1 Products affected

Product hierarchy no. *				Part no.	SBU	Product Type	Customer part no.
SBU	PG	PUG	Type				
02	006	016	0000001608	See list below	Power Entry Modules w/Filter	DG12	-

Product Change Notification					PCN DG12 Inlet gasket integred		
owner	creation date	release date	released by	change order	rev	page	D10-068-630
sariogar	12.10.2022	04.05.2023	sariogar	2024945	A	1 of 2

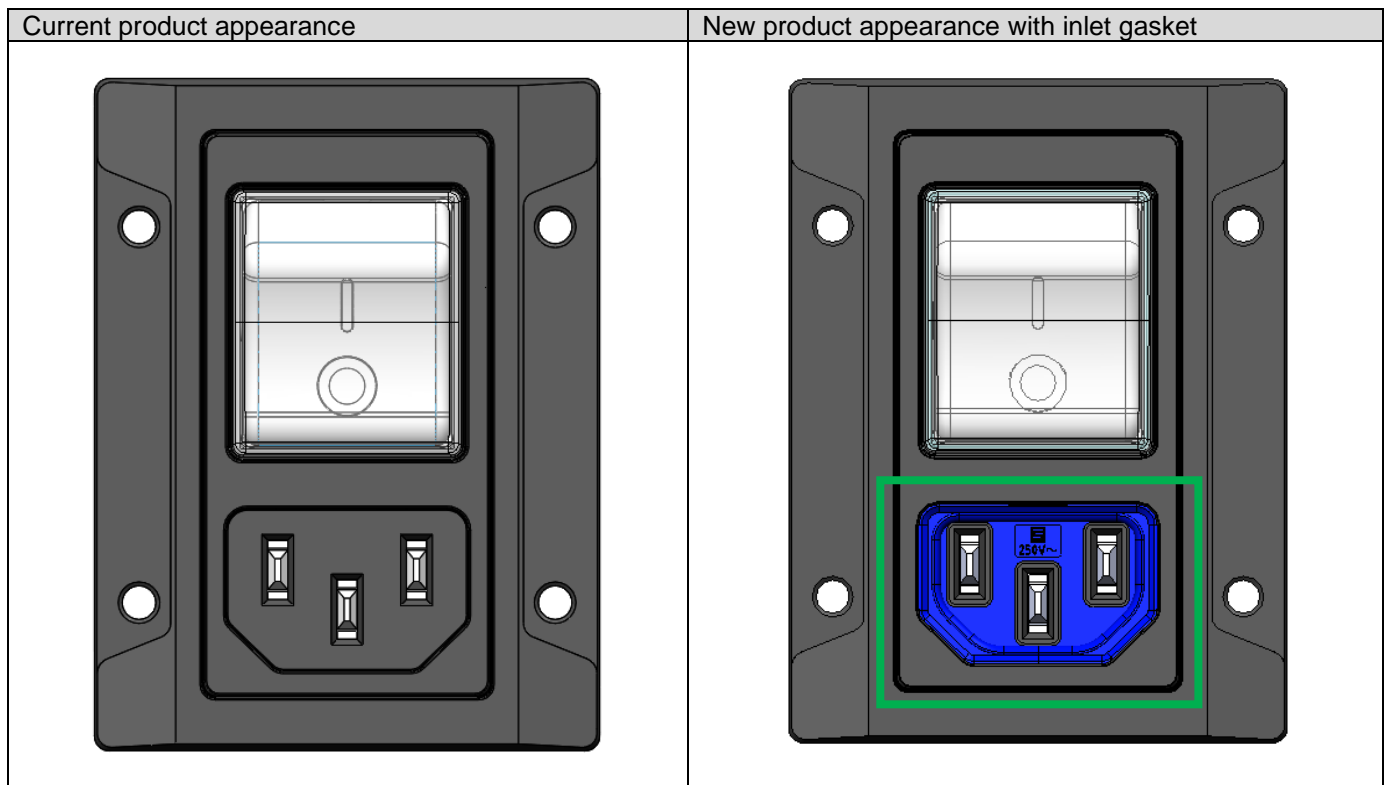
- Additional ingress protection against dust and/or liquids while connected for IP67 variants
- New inlet gasket for Ingress Protection of Power-connection
- Upgrade of Ingress Protection IP54 while connected with dedicated IP54 cordsets

- DG12, IP67 Variants towards housing fulfil new in addition IP54 against the power connection with dedicated IP54 cordsets
- This is done by assembling the blue Inlet Gasket as a standard

| <input checked="" type="checkbox"/> | Form | Inlet gasket integrated |
